Service Newsletter

2200VP/MVP FAN REPLACEMENT WITH LARGE I/O CONTROLLERS

SUBJECT: LVP CHECKLIST PAGE 1 OF 4

FIELD CHANGE ORDER

FIGURE 1 210-7591-A PCB ASSY, CAP LOCATIONS

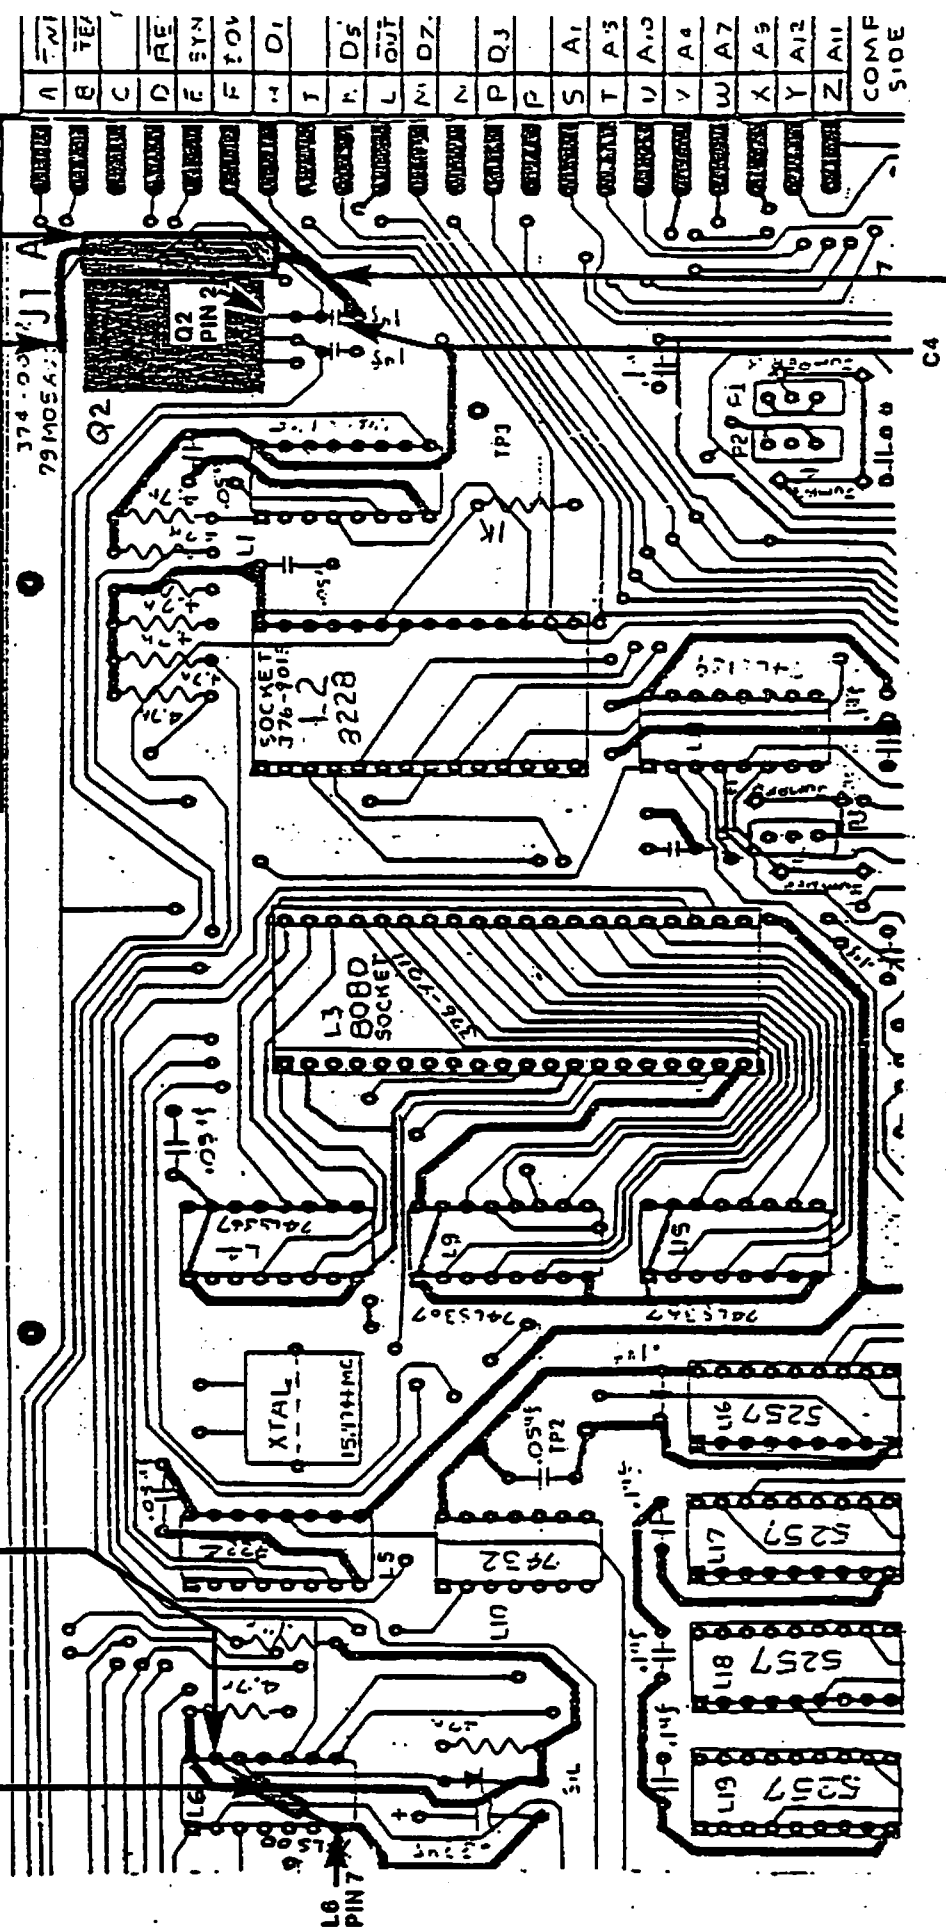
Two capacitors are added to 210-7591 PCB of the 2236 MXD I/O controller.

- A. Ensure power is off.
- B. Remove 2236 MXD I/O controller from 2200 system.
- C. Refer to Figure 1. Solder a 390 pf cap (300-1390) from L6 pin 13 to ground at L6 pin 7 on 210-7591-A PCB assembly.
- D. Add a 30 uf cap (300-3009) from Q2 pin 2 to ground on 210-7591-A PCB assembly.
 - 1. Solder the negative lead of the 30 uf cap (300-3009) to the etch leading to Q2 pin 2 as shown in Figure 1.
 - 2. Solder the positive lead of the 30 uf cap (300-3009) to the negative lead of C4 and to the etch leading to same as shown in Figure 1.
- E. Place E-Rev 1 sticker on 210-7591-A PCB assembly.

ADD A 30UF CAP
(300-3009) FROM
Q2 PIN 2 TO GROUND

ADD A 380 PF CAP
(300-1390) FROM
L6 PIN 13 TO GROUND

ECO NO 47774
SHT 5 OF 7

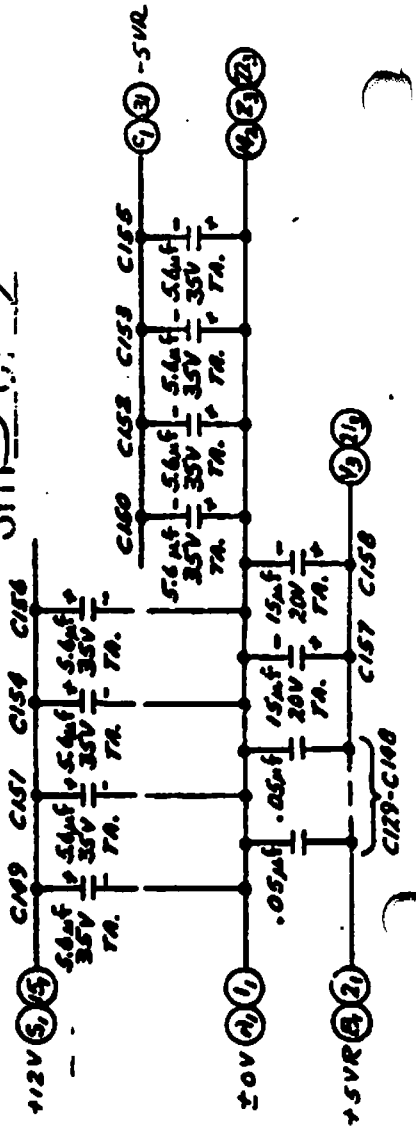
Change assembly drawing, parts list and sample board per attached prints and as follows:

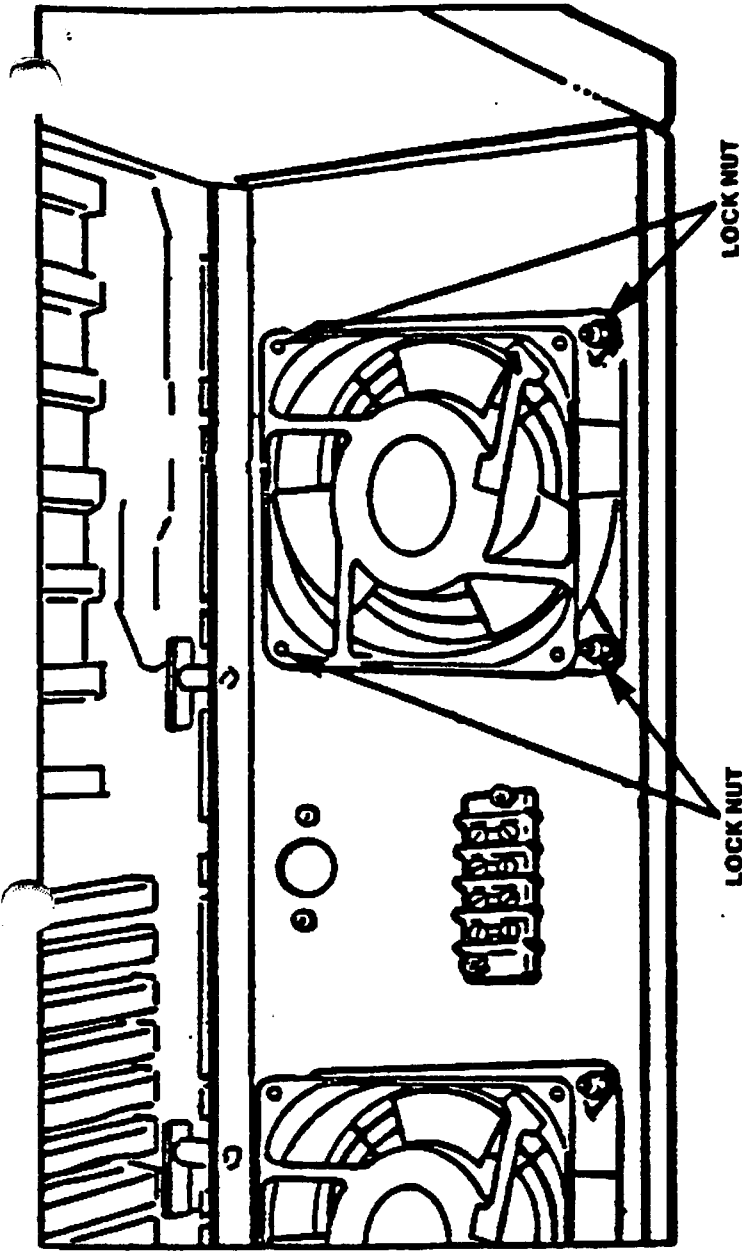
A. Refer to Figure 1. Replace the fan in the I/O section of the VP chassis as follows:

1. Power down unit. Remove AC power plug from wall outlet.
2. Remove the I/O controllers from the motherboard and CPU cards as needed.
3. Disconnect fan cord from old fan (400-1009).
4. Remove the old fan from the chassis. Save the four lock nuts to secure the new fan to the chassis in Item 5 below.
5. Install the new fan (400-1029) on the side panel of the chassis. Hold the fan against the inside of the side panel. When properly placed, the air flow indicator on the fan is at the top of the unit. Secure the fan using four new screws (650-3327) and the four lock nuts saved from Item 4 above.

NOTE: The air flow from the fan blows out of the chassis.

FIGURE 2 MVP FAN INSTALLATION

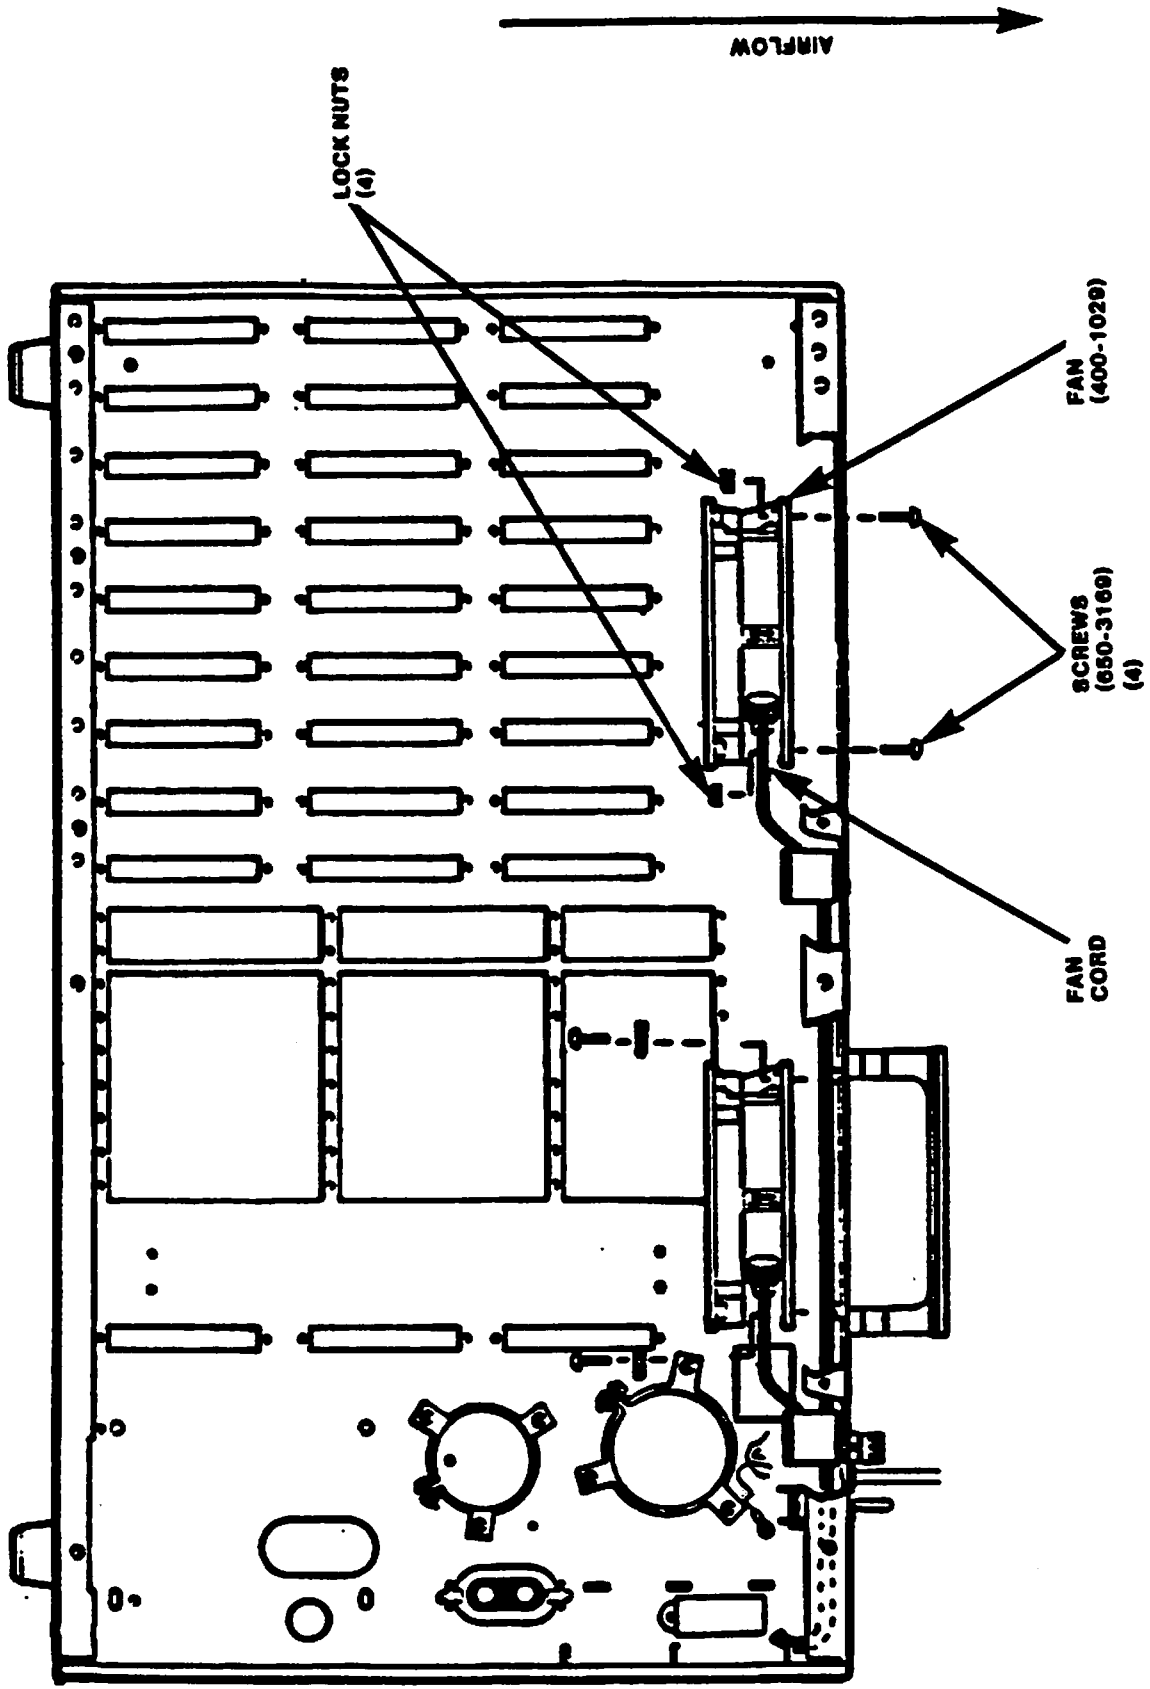
B. Refer to Figure 2. Replace the fan in the I/O section of the MVP chassis as follows:

1. Power down unit. Remove AC power plug from wall outlet.
2. Remove the I/O controllers from the motherboard and CPU cards as needed.
3. Disconnect fan cord from old fan.
4. Remove the old fan from the chassis. Save the four lock nuts to secure the new fan in Item 5 below.
5. Install the new fan (400-1029) on the side panel of the chassis. Hold the fan against the inside of the side panel. When properly placed, the air flow indicator on the fan is at the top of the unit. Secure the fan using four new screws (650-3169) and the four lock nuts saved from Item 4 above.

6. Connect the fan cord to the new fan.
7. Replace the I/O controllers and CPU cards if removed. Proceed to Step D below.
